Addendum No. 01

Activity No. *PK-HESCO-GOODS-AMI METERS ICB/09*

This addendum No.1, in SPD against RFB No *PK-HESCO-GOODS-AMI METERS ICB/09*, is being issued on 25th November, 2025, in accordance

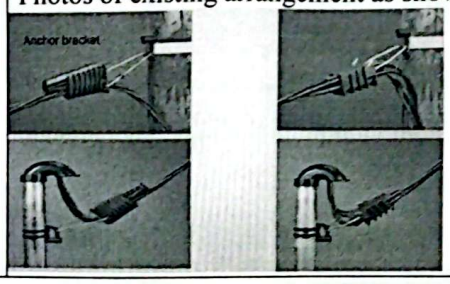
05	Section VII - Schedule of Requirements, Special Conditions Clause.26	Following activities are pre-requisite i. Sim allocation to meters ii. Meter configuration iii. Meter creation iv. Communication Testing v. Meter installation compliance with UDIL vi. Live Communication Testing vii. Data validation viii. Preparation of job card ix. Snapshots along-with latitude and longitude before and after installation x. Addition of complete details of connection like meter serial number, grid name, power	*Deleted.*
06	Specification DDS-82:2007 page number 26-31	WAPDA Specification DDS-82:2007 Page number 26-31	Under heading of bracket for clamping sets mounted on post, poles, structures, pillars, pipes or facets. From above, it is clear for mounting with different type of clamping sets including service dead end clamp. Photos of existing arrangement as shown below.
